Proposal for Supplement 41 to the 03 series of amendments to Regulation No. 37 (Filament lamps)

Submitted by the Working Party on Lighting and Light Signalling*

Category PY21/5W

Sheet PY21/5W/1

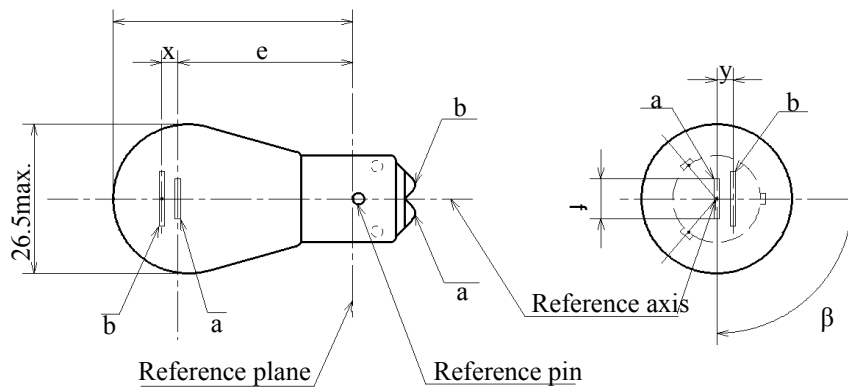
*Insert new sheets PY21/5W/1 to 3, between sheet PY21W/1 and sheet PY27/7W/1, to read:
(see next pages)*

Dimensions in mm	Filament lamps of normal production ^{3/}			Standard filament lamp
	min.	nom.	max.	^{4/}
e		28.6 ^{1/}		28.6 ± 0.3
f			7.0	7.0 + 0/- 2
Lateral deviation ^{2/}			^{1/}	0.3 max.
x, y		^{1/}		2.8 ± 0.3
β	75°	90°	105°	90° ± 5°
Cap BA15d-3 (100°/130°) in accordance with IEC Publication 60061 (sheet 7004-[xxx]-1)				
Electrical and photometric characteristics				
Rated values	Volts	12		12
	Watts	21	5	21/5
Test voltage	Volts	13.5		13.5
Objective values	Watts	26.5 max.	6.6 max.	26.5 and 6.6 max.
	Luminous flux	270	21	
	± %	20	20	
Reference luminous flux at approximately 13.5 V				White: 440 lm and 35 lm Amber: 270 lm and 21 lm

^{1/} These dimensions shall be checked by means of a "box-system". See sheets PY21/5W/2 and PY21/5W/3. "x" and "y" refer to the major (high-wattage) filament, not to the reference axis.

^{2/} Maximum lateral deviation of the major (high wattage) filament centre from two mutually perpendicular planes both containing the reference axis and one containing the axis of the reference pin.

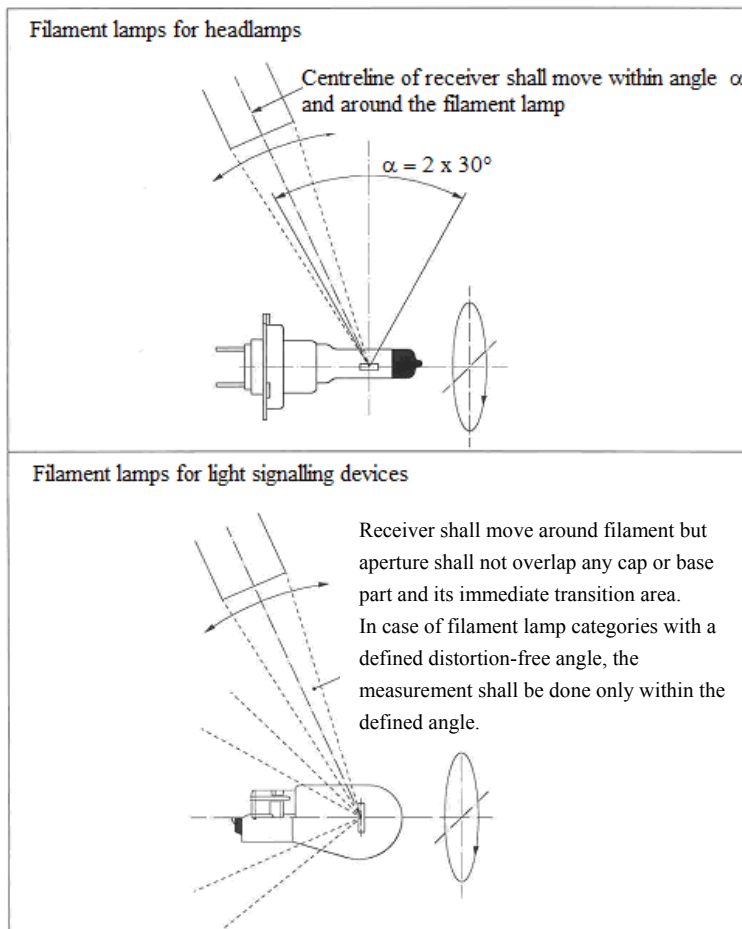
Annex 5, Paragraph 2.3.3., amend to read:

The figure illustrating the positions of colorimetric receiver, the text in the lower part, amend to read:

"2.3.3. For filament lamps used in light signalling devices, measurements shall be made in directions around the filament lamp with exception of:

- (a) The area claimed or covered by the cap of the filament lamp; and
- (b) The immediate transition area along the cap.

In case of filament lamps with two filaments, the centre of the major filament shall be taken.

In case of filament lamp categories with a defined distortion-free angle, the measurement shall be done only within the defined angle."
